Subject: A. TIMING CHANGE - ALL MCM 300 TEMPEST MODELS
 B. INCREASED CUP ON QUICKSILVER CLEAVER PROPELLERS

Figure 1. Blade Cross Section

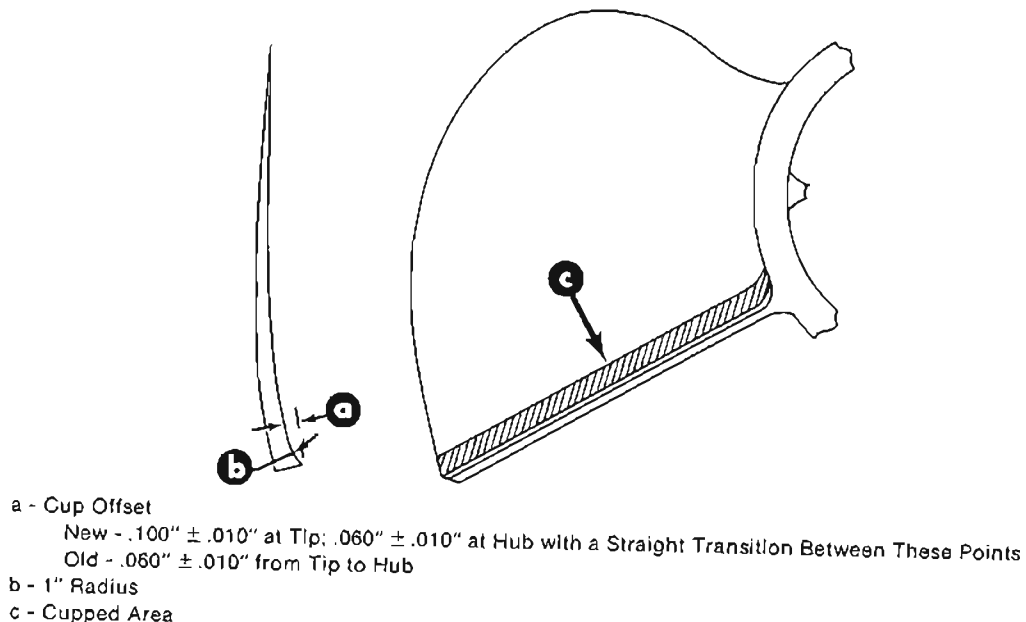
Future production MerCruiser I and TRS Cleaver propellers (part numbers listed below) will be manufactured with additional cup in the trailing edge of the blades. (Figure 1)

Figure 2. Propeller Identification

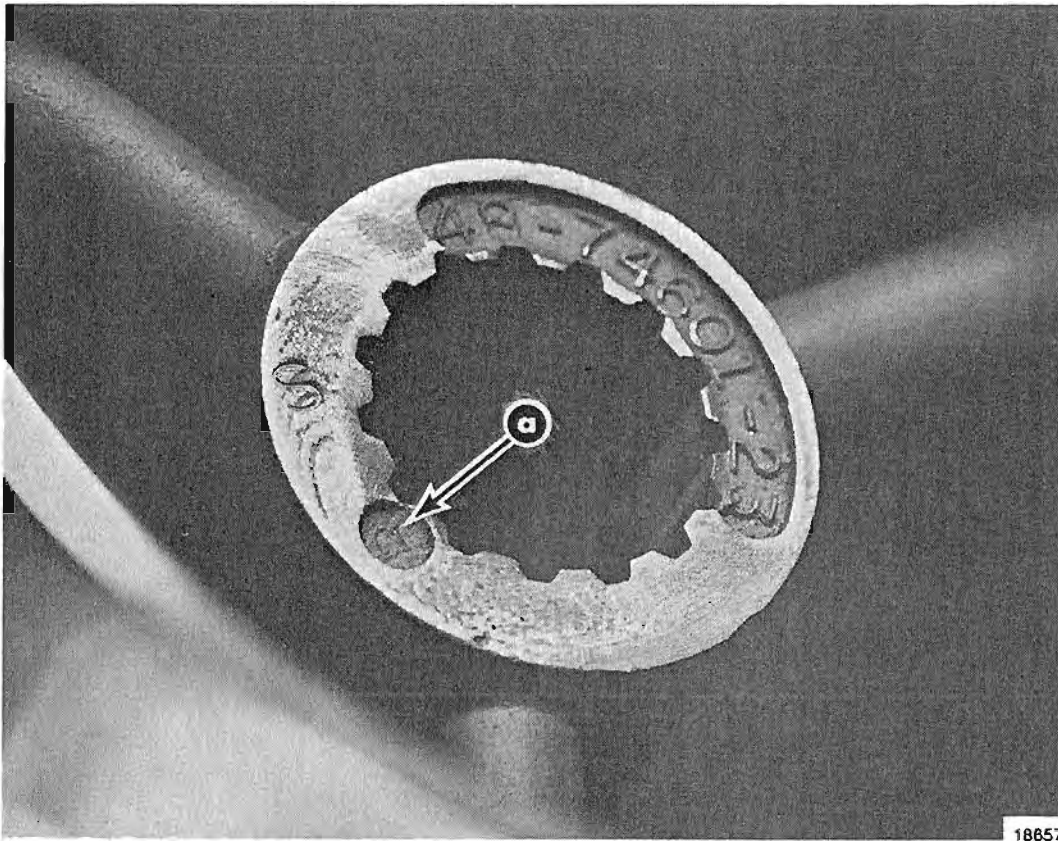
Modification will occur as a running change **without a change to the part number**. Propellers with increased cup can be identified by observing the series letter. (Figure 2)

a - Series Letter
Solid Hub Cleaver - New "R"; Old "P"
Rubber Hub Cleaver - New "E"; Old "D"
